# UNITED STATES PATENT AND TRADEMARK OFFICE

APPLICATION NO.	FILING DATE	FIRST NAMED INVENTOR	ATTORNEY DOCKET NO.	CONFIRMATION NO.
09/822,154	03/30/2001	Robert A. Immerman	IN0191US (#90067)	6306

This is an office action for serial number 09/822,154,  
Suction Cup Holder.

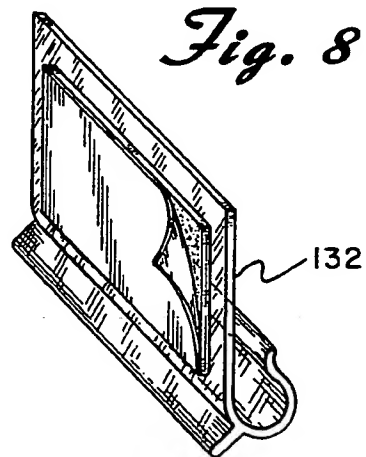
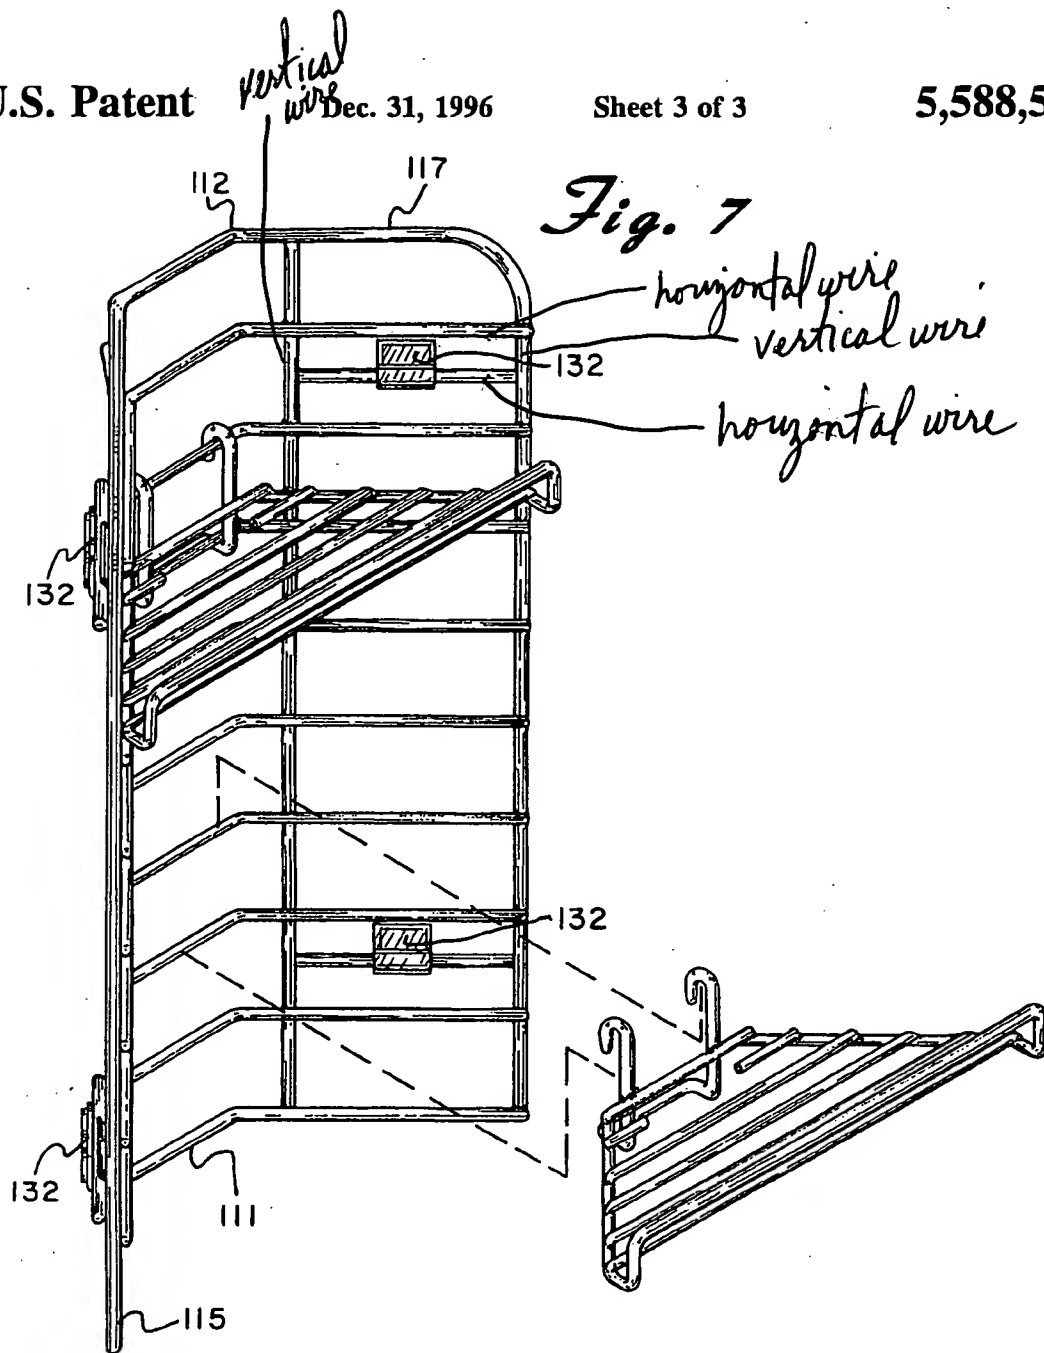
Claim 22 is rejected under 35 U.S.C. 102(e) as anticipated by or, in the alternative, under 35 U.S.C. 103(a) as obvious over Rodack d442,002. The examiner has viewed the claims as being a subcombination the suction cup being only functionally recited and not positively claimed. Rodack (see attached figure) discloses a fixture with vertical wires, and at least one device comprising a generally rectangular structure, having vertical sides, horizontal sides, and four rounded corners, at least two fastener arrangements.

Claims 1-5, and 25 are rejected under 35 U.S.C. 103(a) as being unpatentable over Finger 5,588,543 in view of Thalenfeld 5,887,731. Finger discloses a first pair of

rigid horizontal wires (Figure 7, see attached drawing), a second pair of rigid transverse to the first pair of horizontal wires, two fastener arrangements, a device, and a fixture (117), a suction cup (figure 5, element 32, column 3, lines 42ff) having a head and a neck. Finger discloses all of the limitations of the claimed invention except for the second pair of wires being co-planar to the first pair. Thanlenfeld teaches that it is known to have a rectangular opening having co-planar first and second pairs of wires (figure 1, elements 14 and 16). It would have been obvious to one having ordinary skill in the art to have modified Finger to have the wires being co-planar as taught by Thalenfeld for the purpose of aesthetics and for preventing the wires from being accidentally disengaged or bent. Finger in view of Thalenfeld discloses the claimed invention except for the welding, brazing, or adhesive as the fastener arrangement. The applicant has claimed considered to be one of "using" novel material, patentability of process is linked to patentability of material used, but if process claimed is directed to "method of making" novel material, patentability of process is determined based on inventiveness of process steps themselves, and selection of novel starting material is not

**3,181,702**

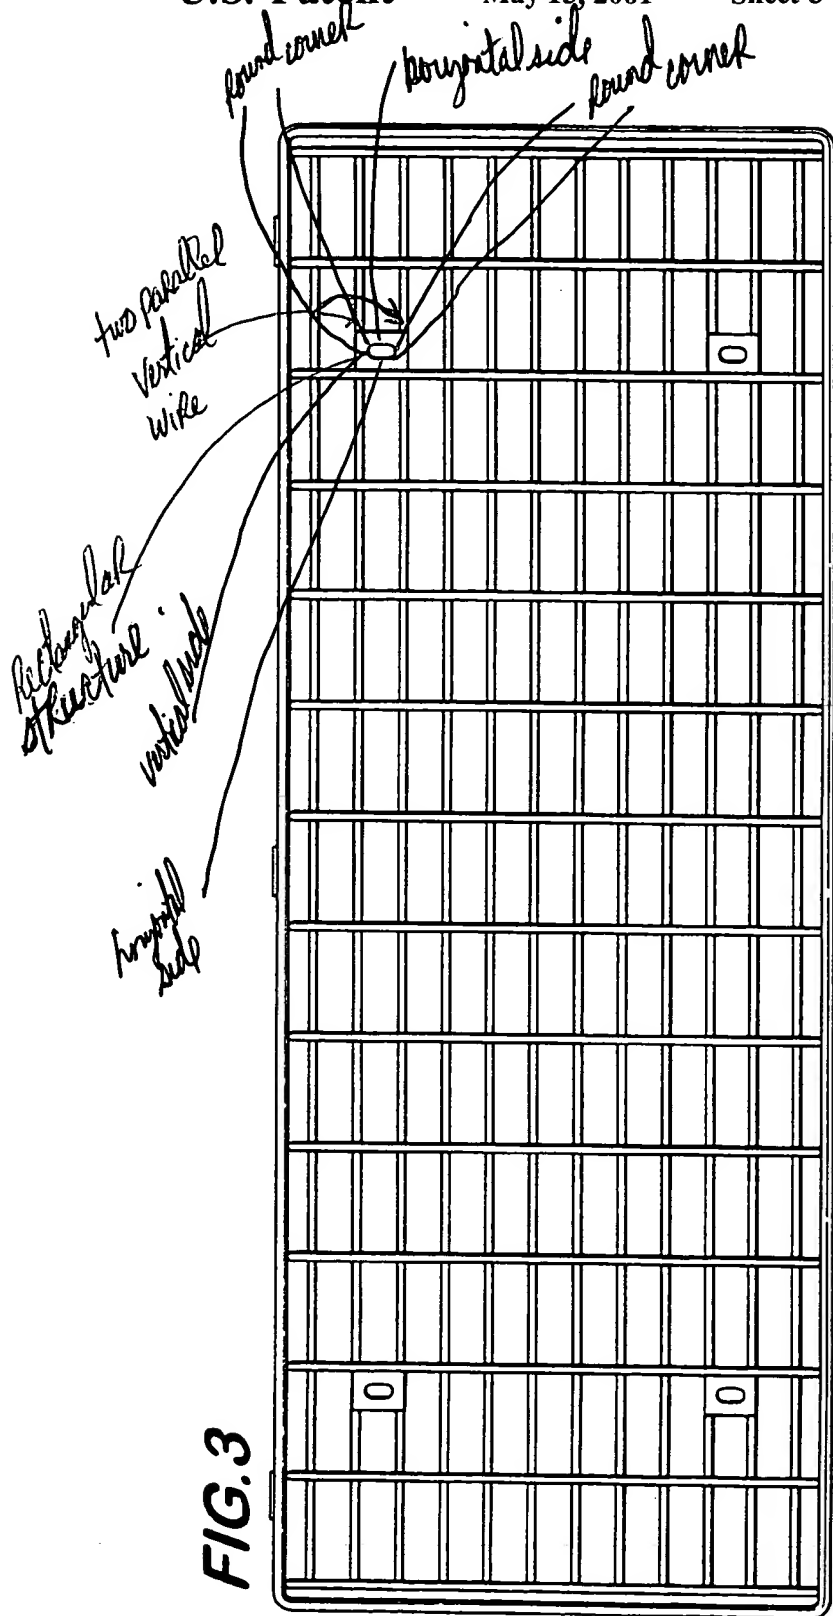
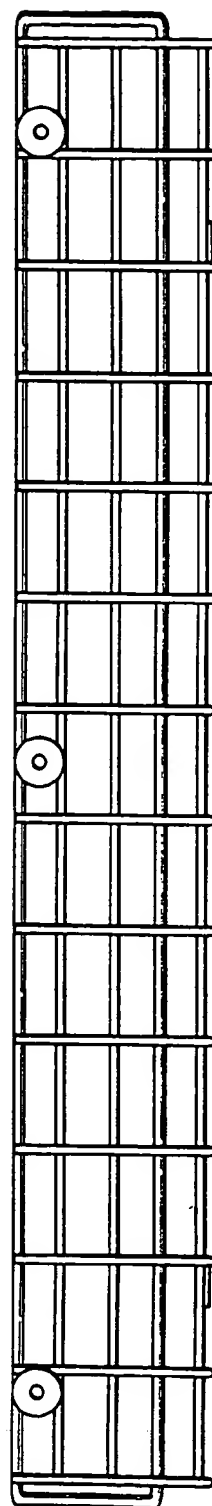
Claims 11-15 are rejected under 35 U.S.C. 103(a) as being unpatentable over Finger in view of Thalenfeld as discussed above in further view of Raphael 3,181,702. Finger in view of Thanlenfeld disclose all of the limitations of the claimed invention except for the suction cup having an engagement member. Raphael discloses a first

pair of horizontal wires (39 and 41), a second pair transverse wires (96), the wires defining a generally vertical rectangular opening (see attached figure), a suction cup with a head and a neck), two fastener arrangements (where the wires are attached to the fixture), and a fixture (50, 42, 43, 51, 52, 47, 48 and 53). The horizontal wire (41) retains the neck of the suction cup (66) within the opening. The wires are attached to the fixture by welds or at least one brazing (column 2, lines 56ff, where 52 and 53 are attached to 39 and where 47 and 48 are attached to 41). It would have been obvious to one having ordinary skill in the art to have modified Finger in view of Thalenfeld to have used the suction cup as taught by Raphael because these two suction cups are art-recognized equivalents at the time the invention was made, one of ordinary skill in the art would have found it obvious to substitute the suction cups.
